CITY OF LAKE GENEVA
PLAN COMMISSION MEETING
MONDAY, NOVEMBER 21, 2016 - 6:30 PM
COUNCIL CHAMBERS, CITY HALL

STAFF REPORT
To Lake Geneva Plan Commission

RE: WAL-MART PAD @ SEC ROUTE 50 & EDWARDS BOULEVARD
GENERAL WRITTEN DESCRIPTION FOR PRECISE IMPLEMENTATION PLAN

PROJECT NAME	SHEET NAME	DATE	DESCRIPTION
THE SHOPS AT LAKE GENEVA	UTILITY PLAN	10/27/16	ISSUED FOR REVIEW
PROJECT No.			
15.GMX.009			
SHEET No.			
C4

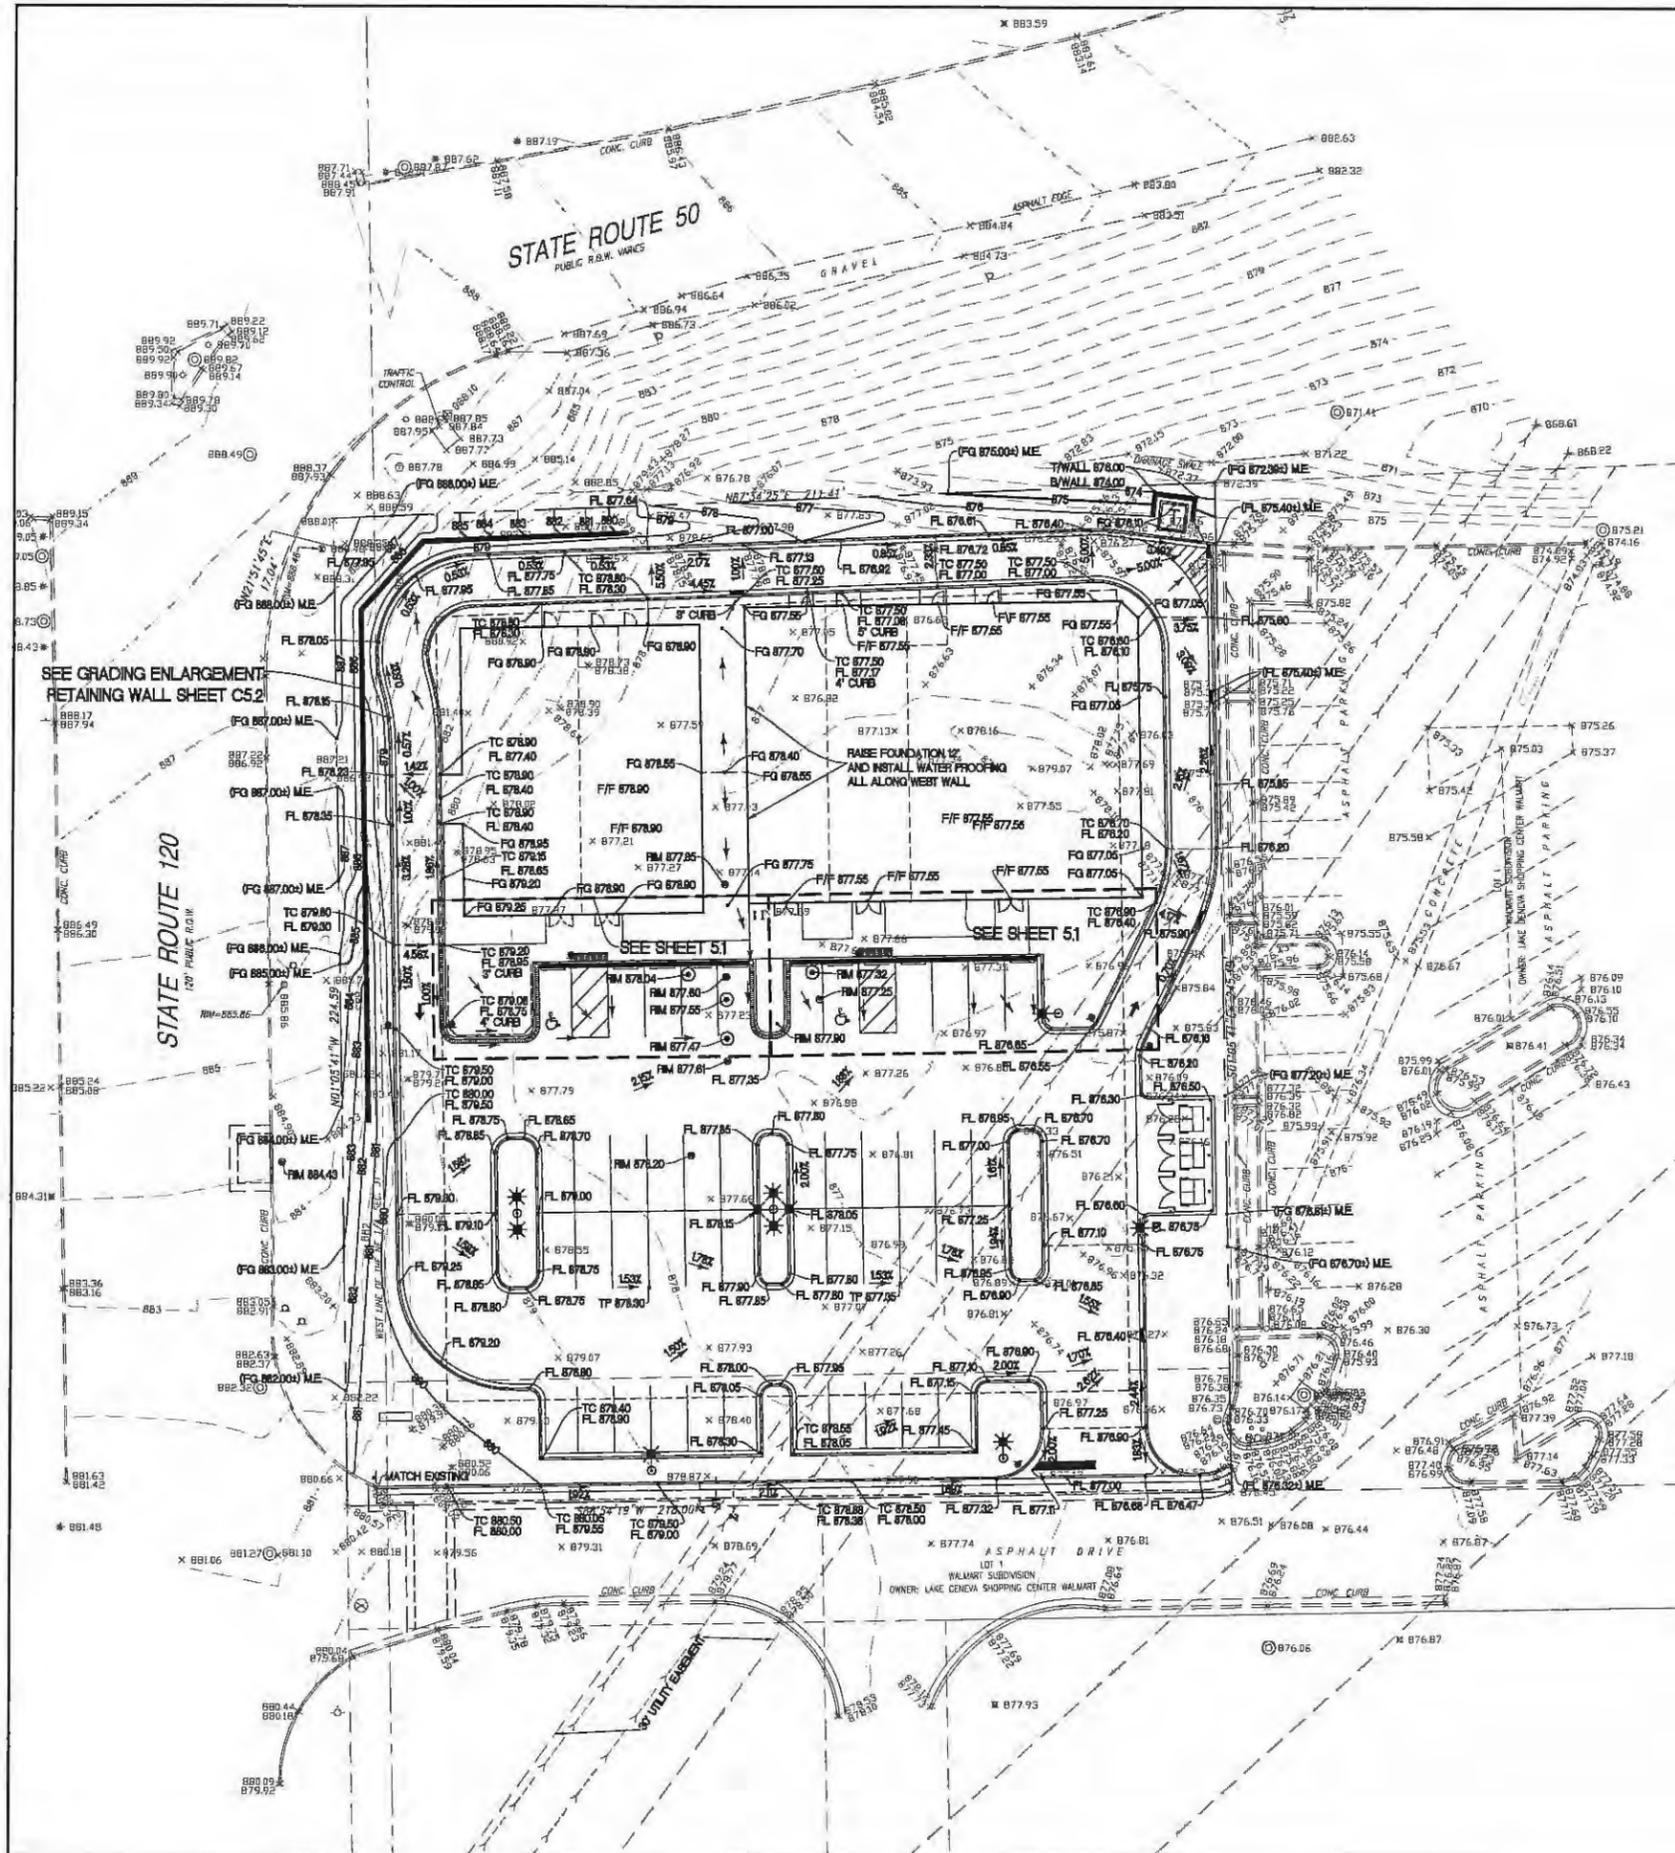
- The Watermain connection sheet C4 key note 1 should be revised to include notification of City two days prior to connection, and the existing watermain revised to an 8". The vault can be removed and replaced with an 8" Gate Valve and box.

- The Watermain key on Sheet C4 specifies Class 52 Ductile pipe which is acceptable. PVC C-900 watermain pipe with tracer wire is more commonly used as it is less costly to install and maintain.

- Sheet C4 Note 9 specifies trench backfill to be used in areas of proposed pavement. The backfill shall be specified as granular backfill meeting the requirements of section 8.43.4 if the Standard Specifications for Sewer and Water. It is noted in the general notes and on the Typical details as the correct backfill.

- Sheet C4 notes 1 and 5 of the water key specify manhole valve vaults and valves. The valve vaults should be replaced with a standard 5 ¼" Valve box for the new installations.

- There appears to be a minor labeling error in the watermain system. The valves at locations 4 and 5 are called out as a 6” but the mains are all 8”. Clarify, and provide a Key item for the watermain Tees also.
- Sheet C8 note 10 of the Sanitary Sewer Provision references the “Village”.
- Sheet C8 Note 16 of the Standard Earthwork, Grading and Paving provisions reference a recent geotechnical report completed by ECS, Midwest. Please provide a copy of the report when available.
